WRITTEN STATEMENT

**BY SAM BLAKESLEE, PH.D.
CALIFORNIA STATE SENATOR, FORMER
CALIFORNIA SEISMIC SAFETY COMMISSIONER, FORMER**

**TO THE
SENATE COMMITTEE ON ENVIRONMENT AND PUBLIC WORKS**

DECEMBER 3, 2014

Figure 10. Comparison of Individual 84th Percentile Ground Motion Prediction Equations with Best Estimate Parameters and Diablo Canyon Review Spectrum

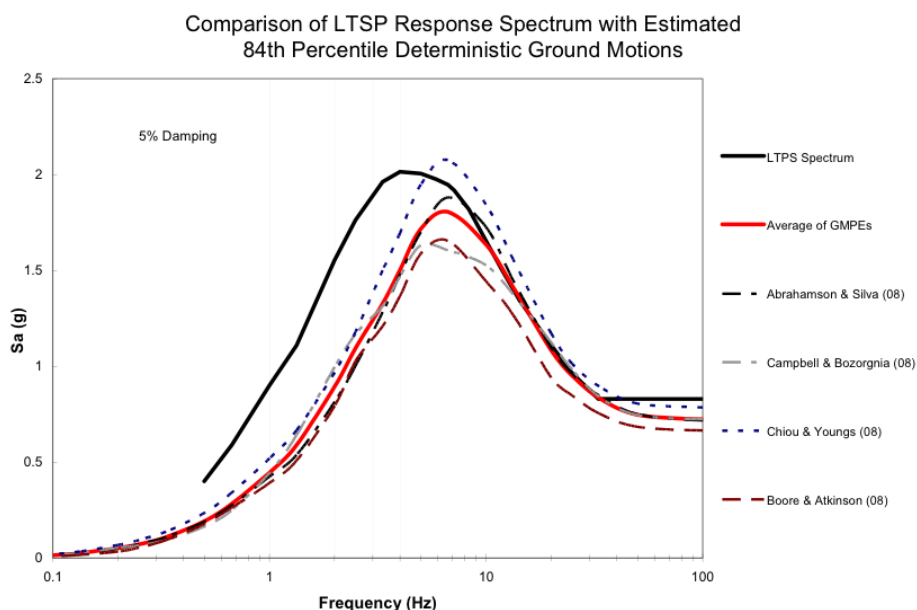
The five NGA GMPEs which, when averaged, produce GMPE-3 are each shown in figure 10 from the NRC report. The NRC staff analysis also tested the significance of using the lower-bound estimate of rock velocity rather than the "best estimate" (lower velocity corresponds to higher shaking). Using a rock velocity of 800 m/s instead of 1,100 m/s resulted in a spectrum that, "exceeds the LTSP spectrum by a small amount over some frequencies." In summary, by using reasonable but somewhat more conservative approaches to the three available variables (the NGA model selection, earthquake magnitude estimate, or rock velocity) the spectrum was found to be "very close" or "exceeds...by a small amount." This result was quite significant because it showed that, even in the early days when the Shoreline Fault was still believed to be relatively small, shaking could exceed the LTSP Spectrum assuming certain models and certain rock parameters. The Chiou & Youngs (08) GMPE

(dotted blue line) exceeds the LTSP Spectrum (solid black line) at about 7 Hz and above, the others are just a little below, hence the characterization that they are “*very close*” (emphasis added).

This result naturally raises important questions about the effect of the new GMPE applied to the Shoreline. For example: would estimation of shaking on a 24 km rupture of the Shoreline Fault have exceeded the LTSP if GMPE-1 was used rather than GMPE-3? Given what is shown in Figure 10 it appears that the answer would likely be “yes” if the difference between GMPE-3 vs GMPE-1 was anything other than de minimis, but that analysis was not performed in the 2009 Shoreline report.

Figure 3: Shakal et. al., 2004 showing remarkably high and low accelerations in the extreme near-field (rupture started where the star is shown and then propagated to the north-east and south-west where they stopped)

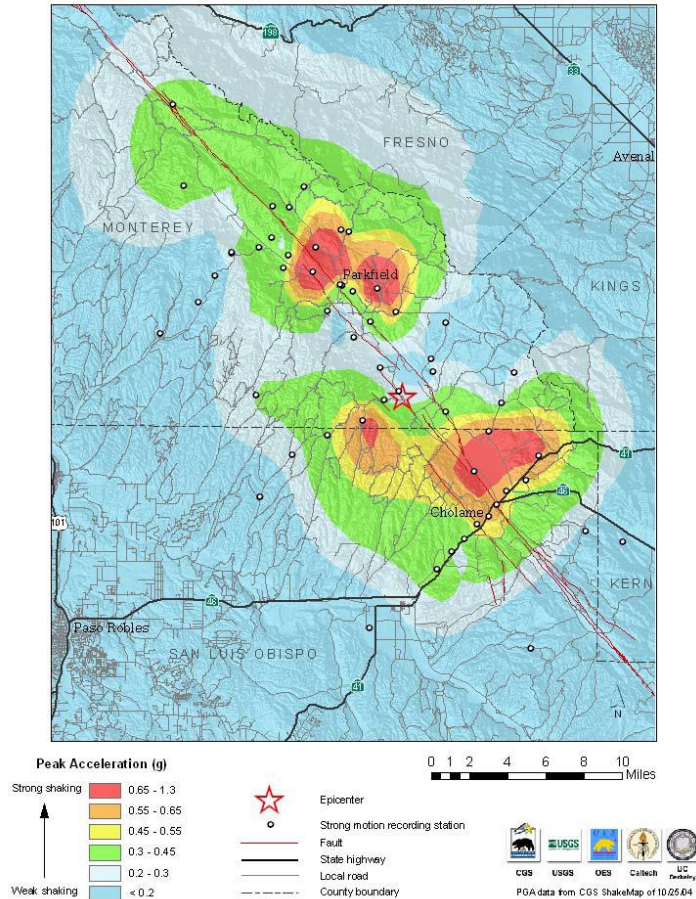
For example, in 2004, 48 strong-motion recordings within 10 km of the San Andreas Fault were made of the M6.0 Parkfield earthquake^{xii}. This dataset was used to test three different attenuation-distance equations. These equations are shown to do a good job of making accurate predictions for distances beyond about 10 km, but the observed shaking becomes highly variable in close proximity to the fault. Rather than finding accurate predictions of mean shaking in the extreme near-field the paper notes,

“Peak ground acceleration in the near-fault region ranges from 0.13 g at Fault Zone 4, to 1.31 g at Fault Zone 14, ten times larger, to over 2.5 g at Fault Zone 16 (where the motion exceeded the instrument capacity and the actual maximum value is still being estimated).”

The dense strong-motion Parkfield recordings are relevant to the conclusions of the Report for a number of reasons.

during the rupture process of this specific earthquake. If the nuclear power plant happens to be located in a zone of focused seismic energy the 84th percentile estimate from the GMPE estimate will likely underestimate the observed shaking.

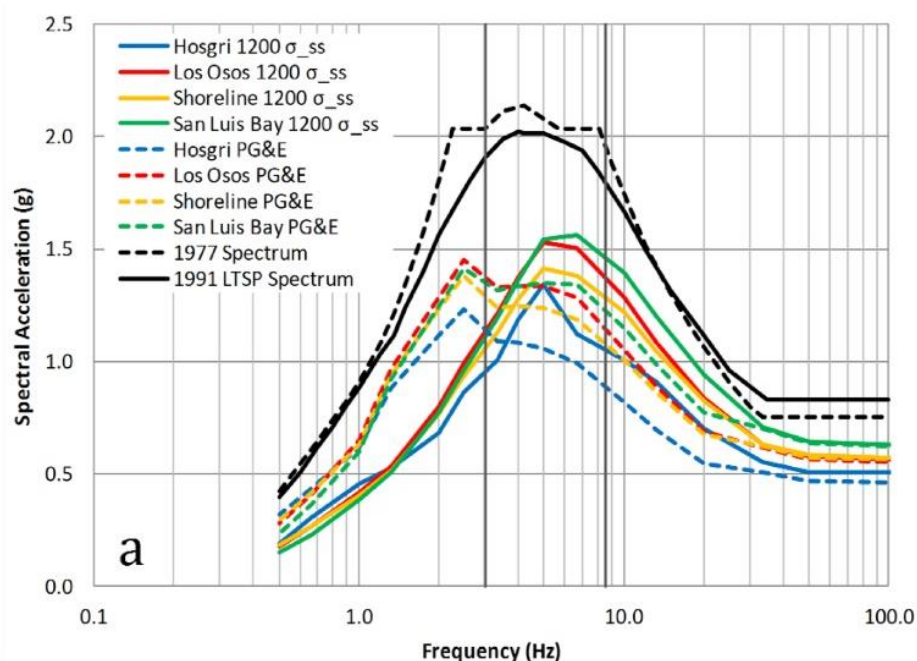
As seen in Figure 7a from the Independent Peer Review Panel (IPRP) report and in a number of other related reports, the new less-conservative equations cause a major reduction in shaking across the entirety of the frequency spectrum from a hypothetical earthquake on the Hosgri fault (compare blue lines which use the newly devised methods with black lines which use the prior methods, in figure 7a above). In the frequency range from 2-10 Hz the less-conservative methodologies have cut the maximum estimated acceleration from 2 g down to about 1.3 g. At the peak-frequency range, from 30-100 hz, the maximum estimated acceleration as been reduced by a third from .75 g to under .50 g. In fact the de-amplification effect is even larger than this comparison suggests because the blue lines, which represent the shaking on the re-interpreted Hosgri, assume a larger rupture on the Hosgri Fault than the earthquake that was used to initially create the 1977 HE basis exception.

More importantly, as can be seen in Figure 7a the shaking from the Los Osos, Shoreline, San Luis Bay Faults all exceed the re-interpreted Hosgri (red, yellow, green lines are all above the blue line). **One can reasonably conclude that, if the original analytical methods had been used to estimate ground motion, the new seismic threats would exceed the original HE and LTSP spectra.**

Figure 7. Continued.

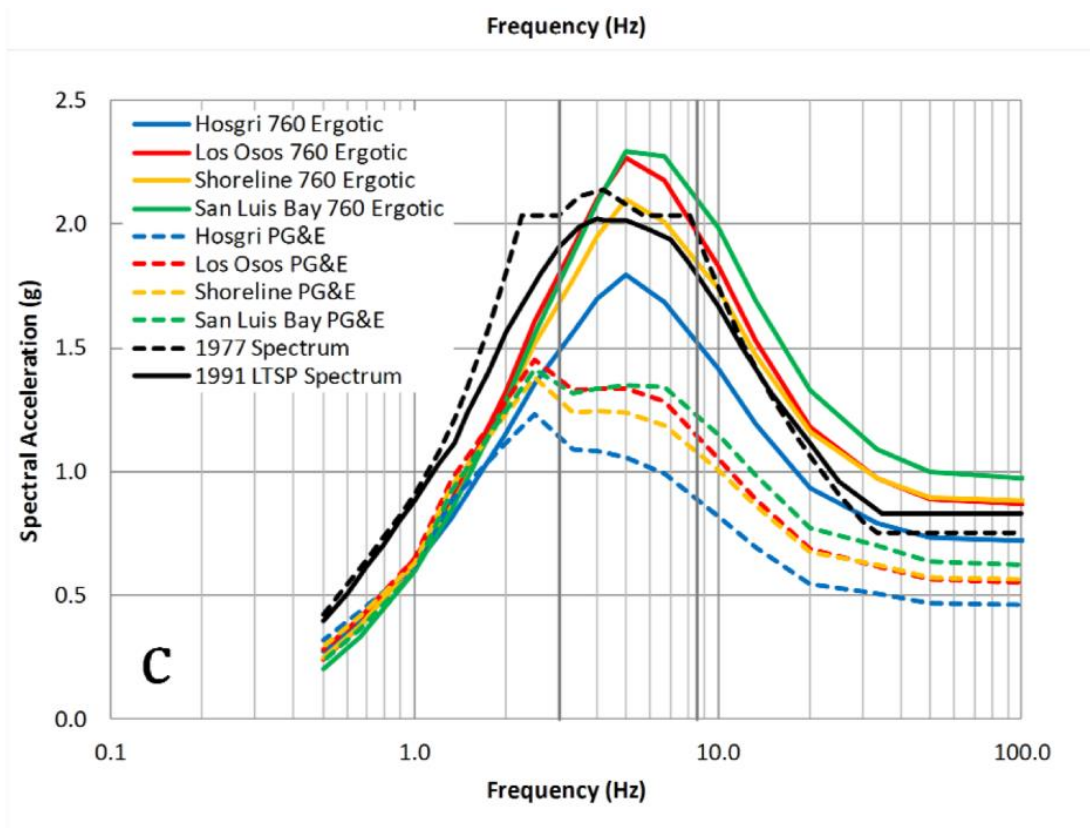
“These two figures also show that if DCPD site had a Vs30 value of 760 m/s rather than 1,200 m/s, and if the site behaves more like an average site in ground motion amplification, **some deterministic spectra would exceed the 1991 LTSP spectrum^{xiii}**” (figure 7c below).

In fact, it is more than just “some.” Under the scenario shown in Figure 7c the IPRP shows that the LTSP/HE spectrum is exceeded by **all** of the newly discovered and re-interpreted seismic threats, including earthquakes on the Shoreline Fault, the Los Osos Fault, and the San Luis Bay Fault (note that the red, yellow, and green lines are all above the solid black line). The fourth and largest hypothetical earthquake scenario, a M7.3 rupture on a joint Hosgri/Shoreline Fault, is not shown on this figure but could reasonably be assumed to exceed the LTSP/HE as well.

This sensitivity analysis shows that the cumulative effect of less-conservative fast rock velocities along with less-conservative GMPEs is clearly not a small issue, nor is it a only an academic issue. The IPRP reviewed the limited wellbore data (see IPRP Report 6 Figure 4) and concluded that the wellbore velocities appeared to be lower than those estimated by PG&E, which could result in the conclusion that PG&E has underestimated shaking from new seismic threats even if the new equations are allowed. The IPRP challenged PG&E's use of wellbore data at the ISFSI site to justify the higher 1,200 m/s velocity and instead focused on the velocities measured in the wellbore data closest to the facility.

Figure 4. Shear wave velocity profiles from 1978 downhole velocity surveys (provided by PG&E).

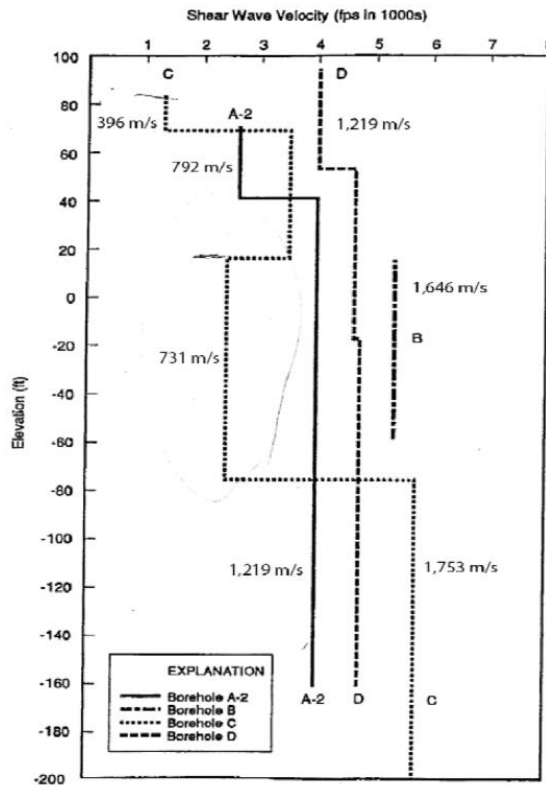
"Consider the three usable measured profiles, A-2, C, and D, the mean value at 10 m is approximately 800m/s, considerably below PG&E's mean of 1200m/s." and "If A-2 had the same velocity as C at a depth of 5m, consistent with the relative weathering described in the borehole logs, the mean velocity at that depth would be about 650m/s, also below PG&E's mean value of 1000m/s."

Second, even if one were to accept the use of GMPE-4, which is problematic for the reasons previously stated, the critically important rock velocities upon which the de-amplification factors are based are complex, in dispute, and arguably lower than those used by PG&E, which would mean that shaking would be significantly larger than stated in the Report. Indeed, a conservative approach toward this technical question would have used of the lowest velocities found in the well data rather than the highest.
